Subject: Transmittal of Revision 1 to Service Bulletin Number V2500-NAC-78-0117

# M2500 International Aero Engines SERVICE BULLETIN

NACELLE - THRUST REVERSER - FAIRING ASSEMBLY, THRUST REVERSER ACTUATOR - MODIFICATION OF

V2500-NAC-78-0117 Page 1 of 16

Thrust Reverser Non-locking Actuator Fairing
Trim/Modification - LH Upper Shown, Lower Opposite
Figure 2

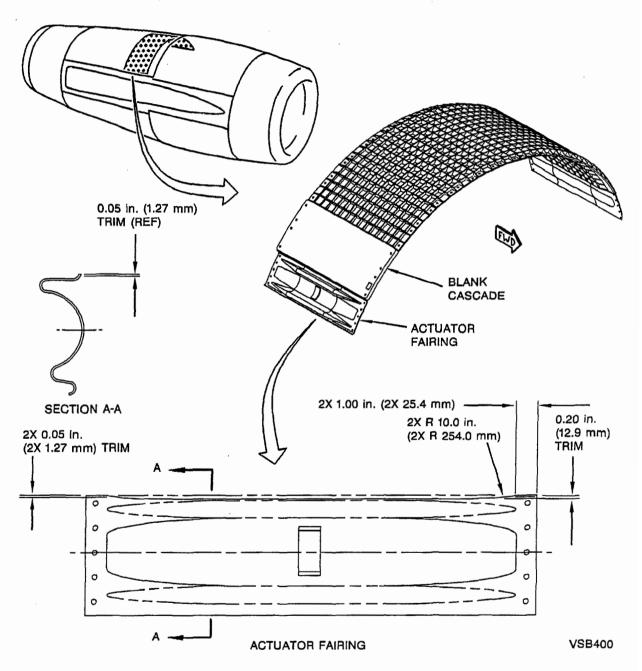
- Part 3 If no damage is found, the modification can be done after the removal of the adjacent blank cascade for access. The modification will trim away 0.20 inch (5.08 mm) of material along the fairing length and 0.050in. (1.27 mm) from the fairing ends on the fairing/cascade mating edge. After trimming, chemical conversion coating will be applied to the exposed edge followed by an application of primer. The blank cascade will then be reinstalled. Refer to Figure 2, page 12.

- D. Rework or Modification Instructions Part Three
  - (1) Remove the blank cascade adjacent to the non-locking actuator fairing assembly. Refer to MD-90 Aircraft Maintenance Manual, Chapter 78-32-15, Page Block 401.
  - (2) Rework the 290-0031-503 Non-locking Actuator Fairing Assembly.
    - a. Trim the fairing to the dimension shown in Figure 2.
    - b. Break any sharp edges after trim (0.015in. max) (0.381 mm max).

- (f) Mix primer base (CoMat 07-071), primer converter (CoMat 07-067), and thinner (CoMat 07-066). Refer to the manufacturer's instructions.
- (g) Apply primer to the trimmed area of the fairing.
- (h) Reidentify the reworked 290-0031-503 fairing assembly to 290-0031-507 with a rubber stamp and black ink (CoMat 06-073). Refer to IAE V2500 Standard Practices/Processes Manual, Chapter 70-09-00.
- (3) Reinstall the blank cascade. Refer to MD-90 Aircraft Maintenance Manual, Chapter 78-32-15, Page Block 401.
